Application of PACIFIC GAS AND ELECTRIC  
COMPANY, a California corporation, for a Permit  
to Construct the Fulton-Fitch Mountain  
Reconductoring Project

**PACIFIC GAS AND ELECTRIC COMPANY'S  
PETITION FOR MODIFICATION OF DECISION 17-12-012**

**PACIFIC GAS AND ELECTRIC COMPANY'S  
PETITION FOR MODIFICATION OF DECISION 17-12-012**

Figure 2.2-1: Project Overview Map

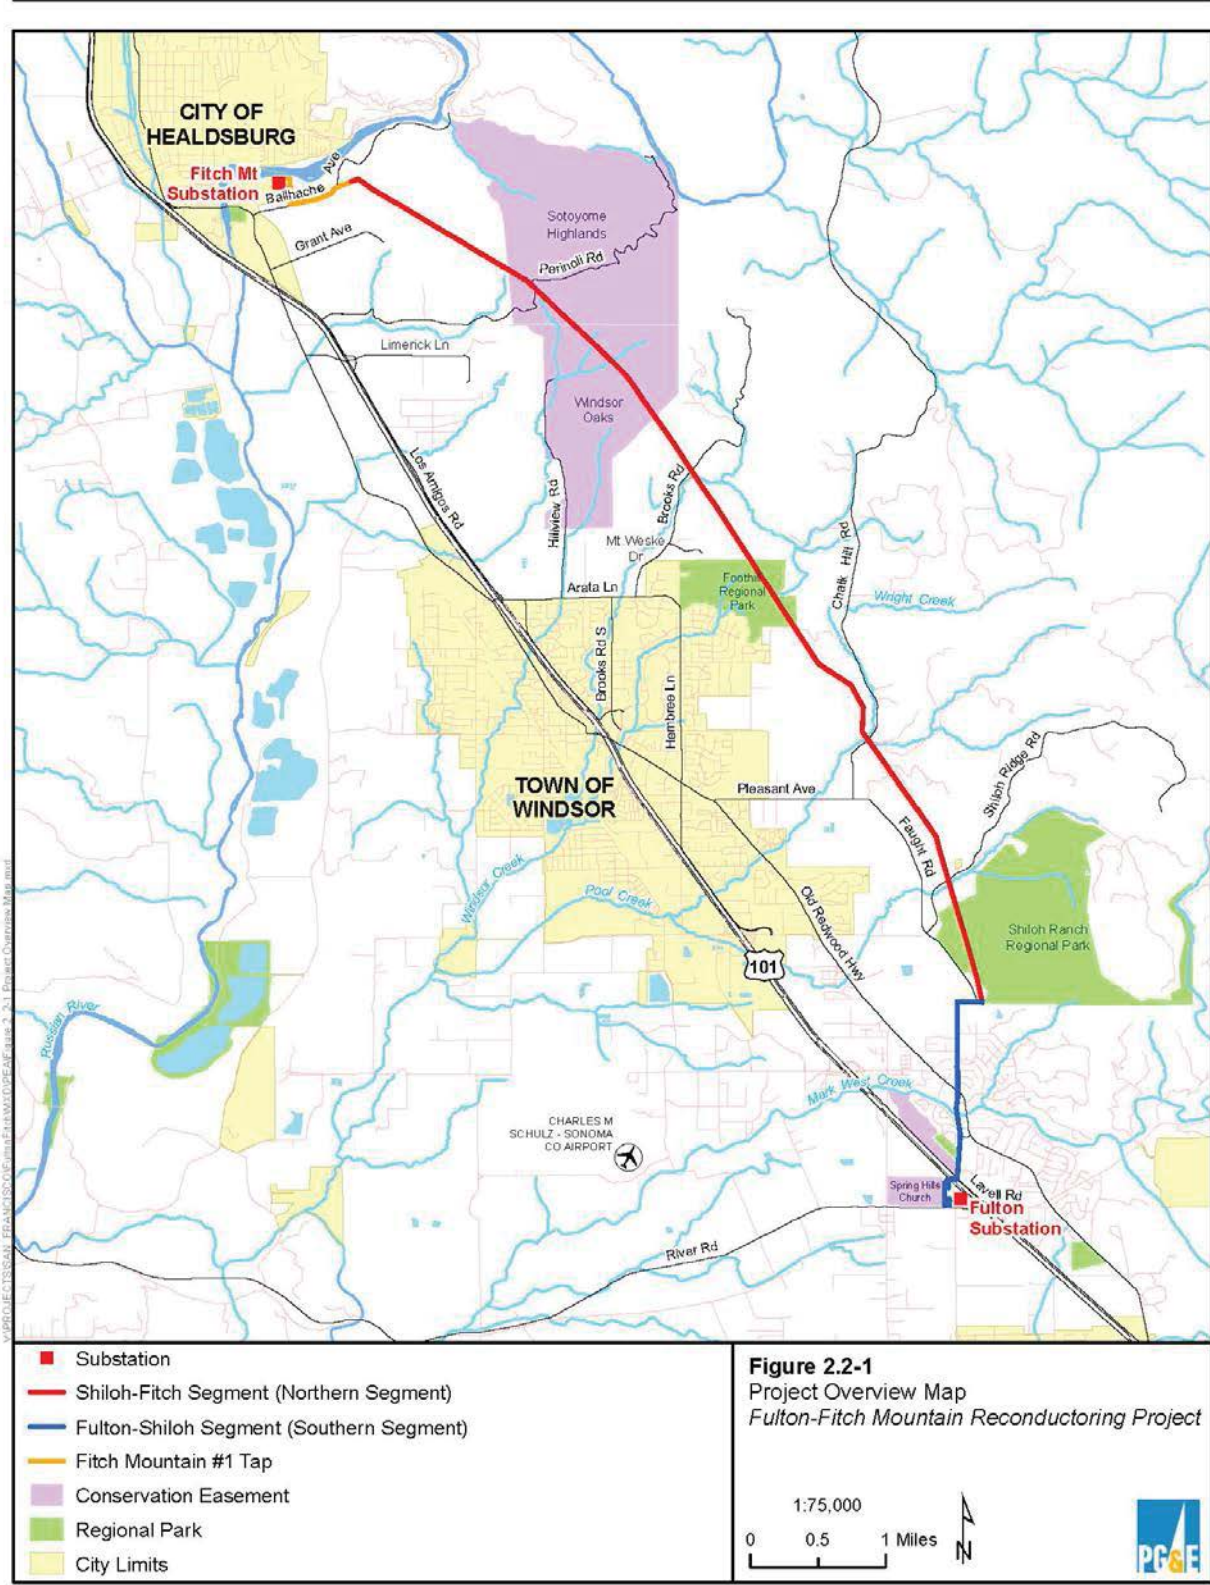
As shown in Figure 2.2-1: Project Overview Map, the Fulton-Fitch Mountain Reconductoring Project is located in unincorporated Sonoma County between the communities of Fulton and Healdsburg. The proposed project modifications consist of replacing 21 tubular steel poles (TSPs) along approximately 1.4 miles of alignment in the project's Southern Segment. These poles currently support the Geysers #12 and Geysers #17 230 kV transmission lines (Geysers 230 kV lines or 230 kV lines) as well as the Fulton-Hopland 60 kV Power Line (Fulton-Hopland line or 60 kV line). This segment is described in the project's 2017 Final MND at page 2.2-2.

No TPSs in the Southern Segment were previously identified for replacement, with primarily conductor replacement (reconductoring) planned for this segment. As project design progressed, PG&E engineers determined that interior corrosion in the connection compartments and weldments of the crossarms on the 21 additional poles could jeopardize the integrity of the poles during reconductoring. To address this safety concern, PG&E is proposing to replace the poles.

**Figure 2.3-1: Existing Conductor Configuration**

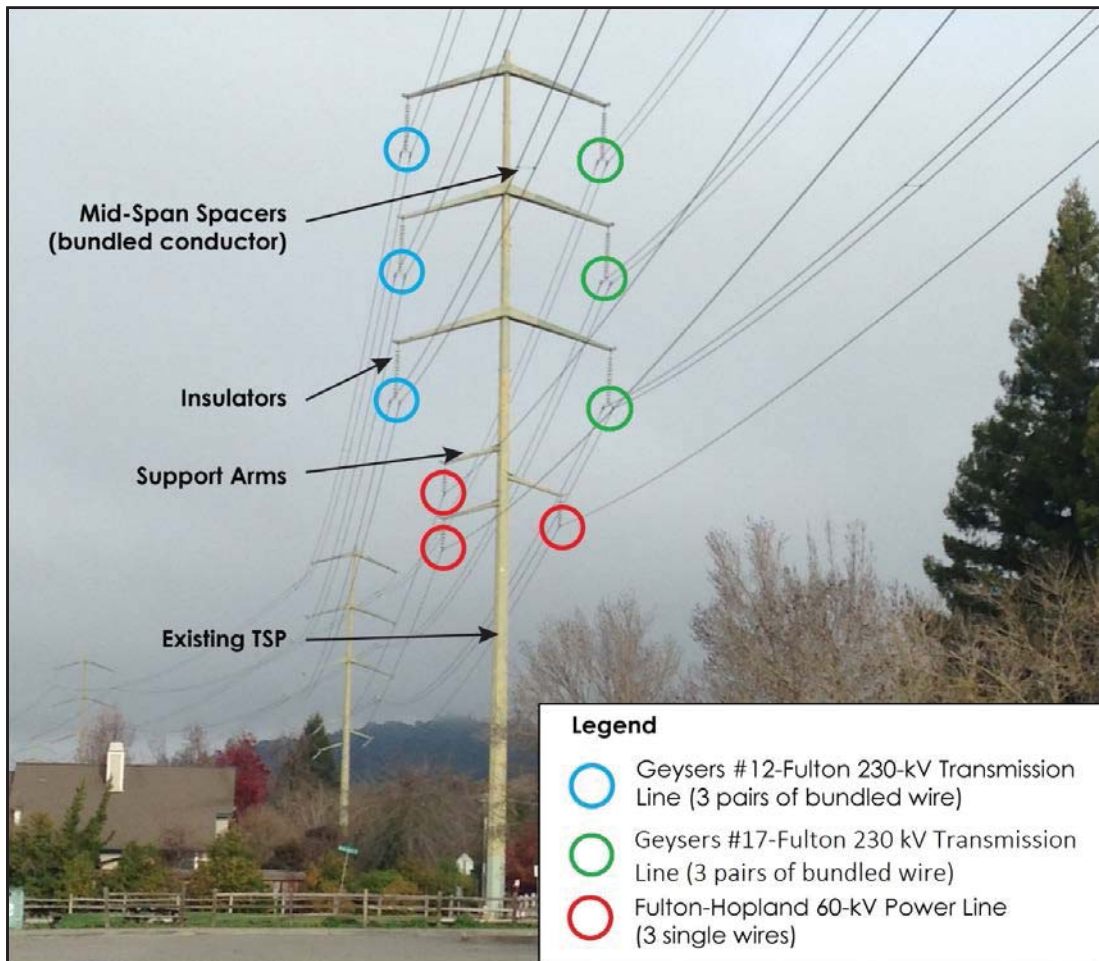
As shown in Figure 2.3-1, the existing 230 kV conductors consist of three bundled conductors arranged vertically on either side of the pole. The Geysers #12 circuit consists of the 230 kV conductors on the north and west sides of the pole; the Geysers #17 circuit consists of the 230 kV conductors on the south and east sides of the pole. The three 60 kV conductors that comprise the Fulton-Hopland Line are arranged in a vertical delta configuration, with two conductors on one side of the pole and one conductor on the other side.

The configuration of conductors on the new TSPs will not change, although the conductors currently on hairpin structures will be arranged on two structures. For the latter, the Geysers-Fulton #12 230 kV conductors will be arranged vertically on the north or west pole and the Geysers-Fulton #17 230 kV conductors will be arranged vertically on the south or east pole. Two of the 60 kV conductors will be arranged vertically below the Geysers-Fulton #12 and the third conductor of the 60 kV will be located below the Geysers-Fulton #17.

Figure 2.3-2: Typical Tubular Steel Pole

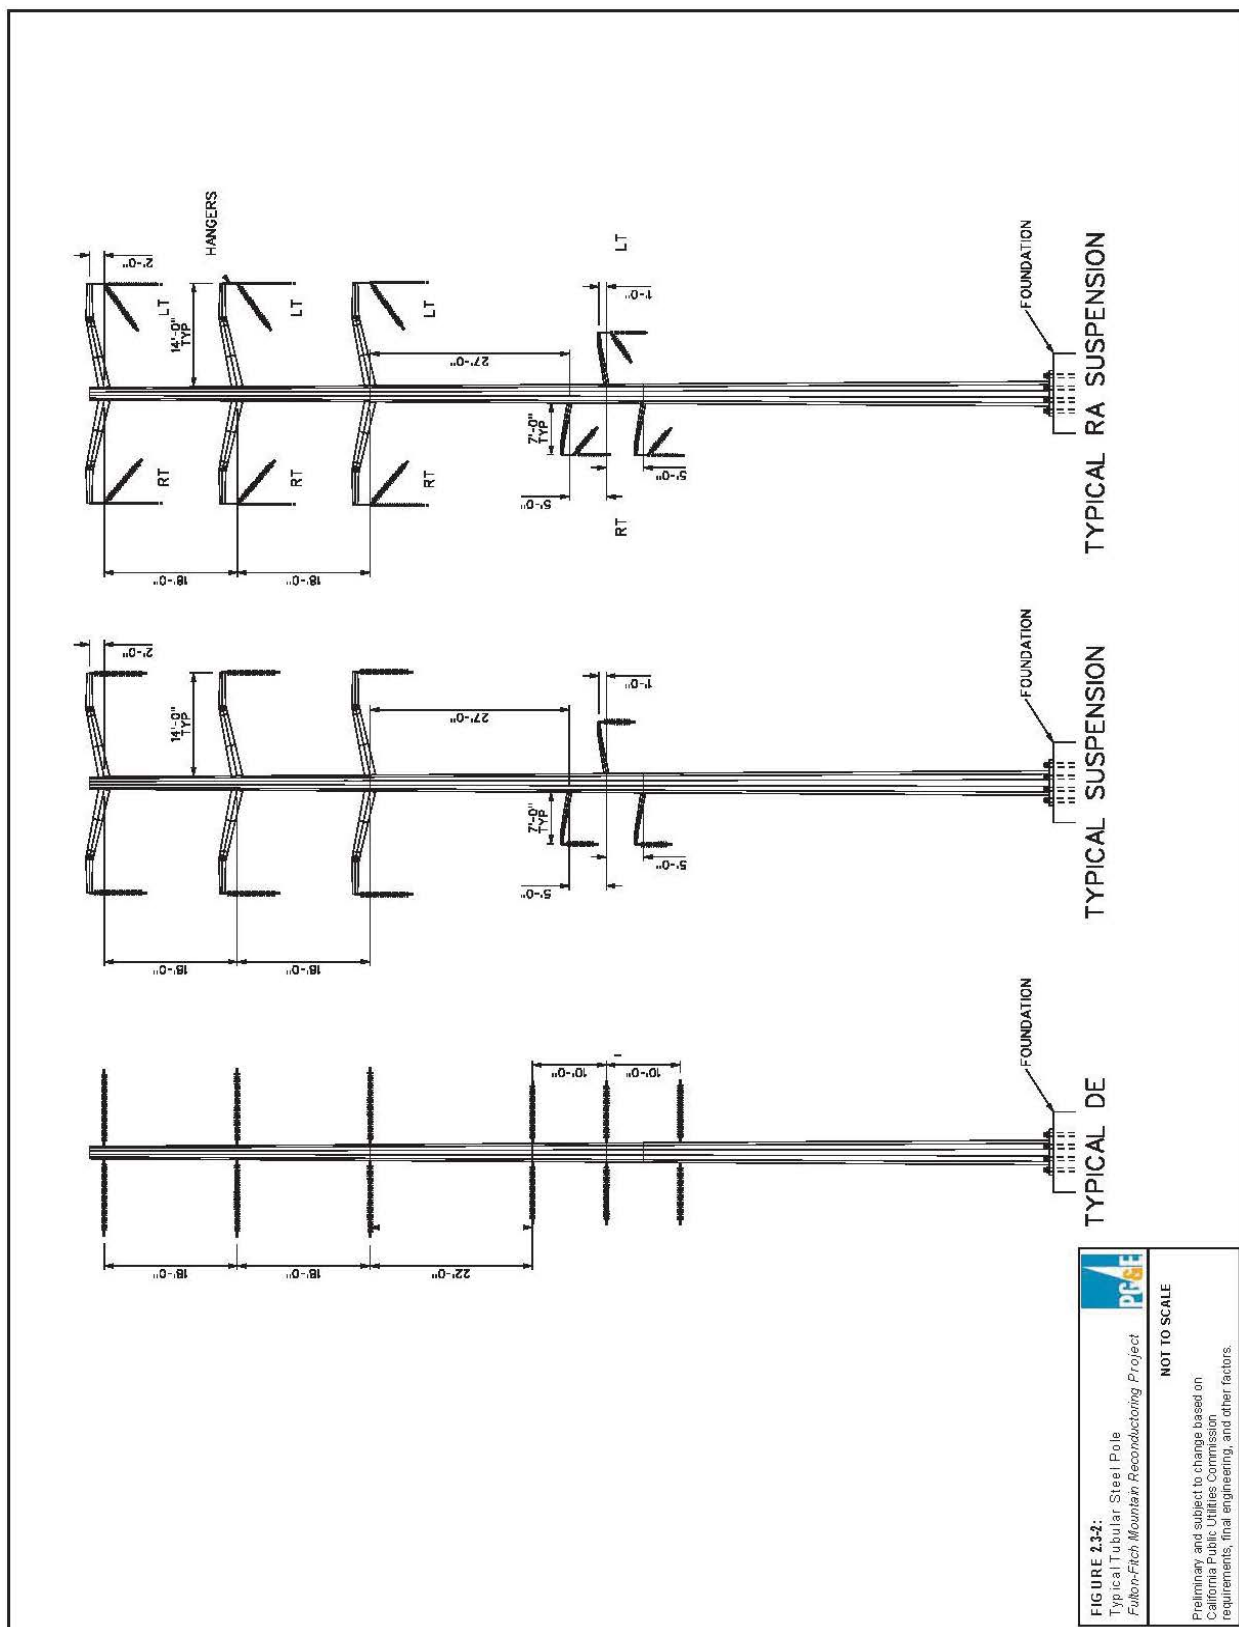
Replacement TSPs will typically be approximately 3-4 feet wide at the base and 1-2 feet wide at the tip and range in height from approximately 135 to 145 feet. Tangent poles will be used along straight portions of the alignment and two single-shaft poles will replace the existing hairpin structure when the run of poles changes direction. All TSPs will have concrete pier foundations measuring approximately 5 to 7 feet in diameter and 20 to 30 feet deep, and extending 1 to 2 feet above ground. Existing guy wires will be removed and structures will be free-standing. Proposed pole dimensions are provided in Table 2.3-3 below.

The replacement TSPs will have a dull galvanized steel surface. New poles will be installed approximately 15-35 feet from the existing pole locations and in line with the existing conductors. Drawings of the typical designs for TSPs are provided in Figure 2.3-2 Typical Tubular Steel Pole.
